CITY OF ALBUQUERQUE

**Re: Cuba Botanicals LLC Grow Facility
5904 Florence NE, Albuquerque, NM 87113
Traffic Circulation Layout
Engineer's/Architect's Stamp 5/22/2024 (B18D030)**

Based upon the information provided in your submittal received 5/23/2024, the above referenced plan cannot be approved for Building Permit until the following comments are addressed:

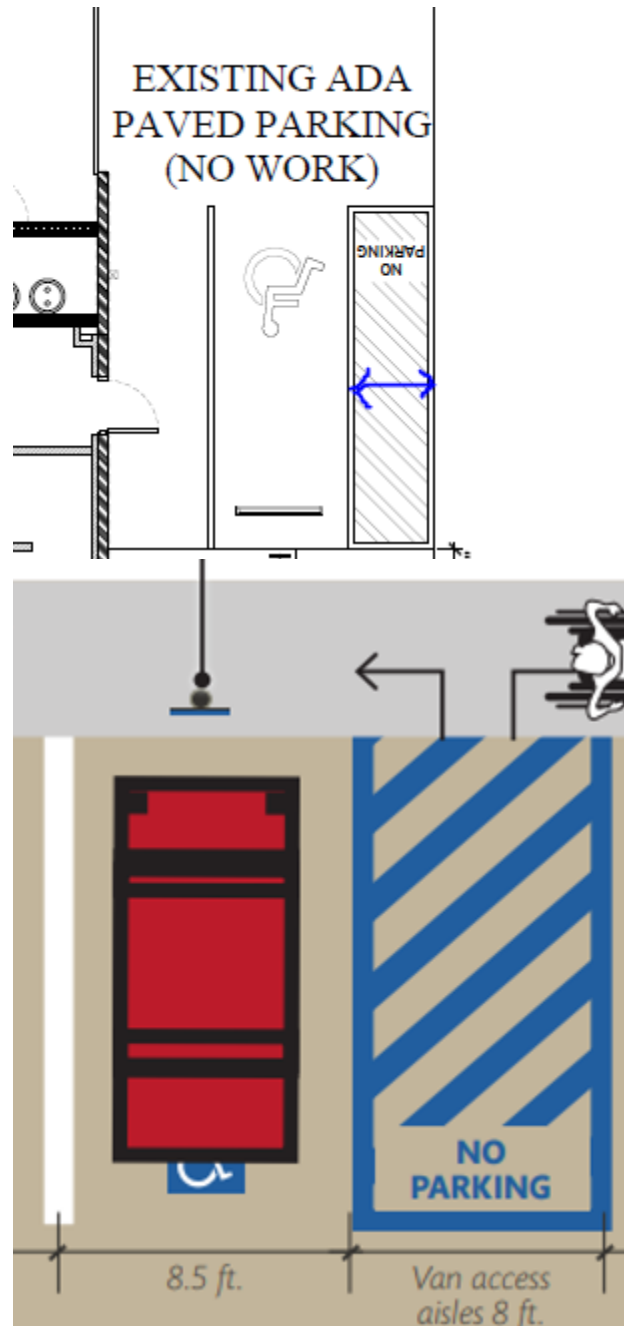
1. Correct the address shown on the general info.

2. A minimum Three Bicycle spaces are required, or two Bike racks

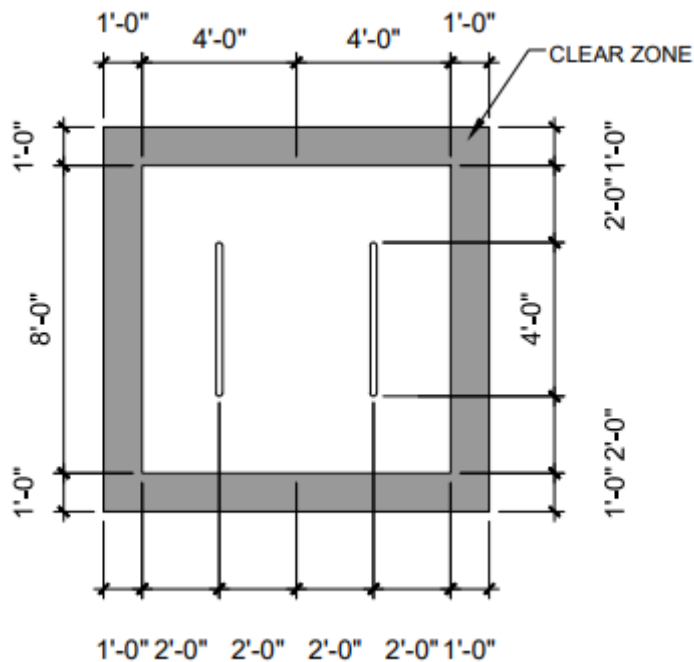
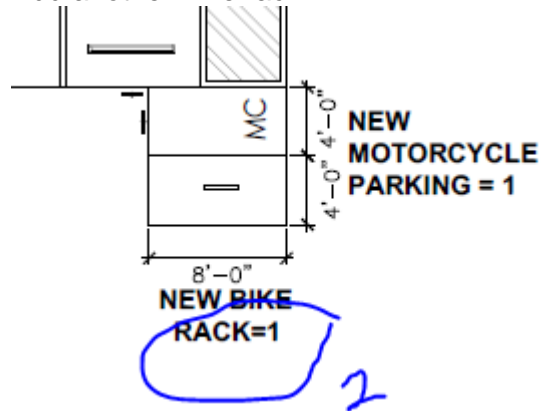
3. All accessways to the site from the adjacent roadway shall be ADA-compliant. Gravel path is not acceptable.
4. Show the dimensions of the existing H.C. parking, this should be for van parking with 8 ft wide van access aisle

5. Add another Bike rack
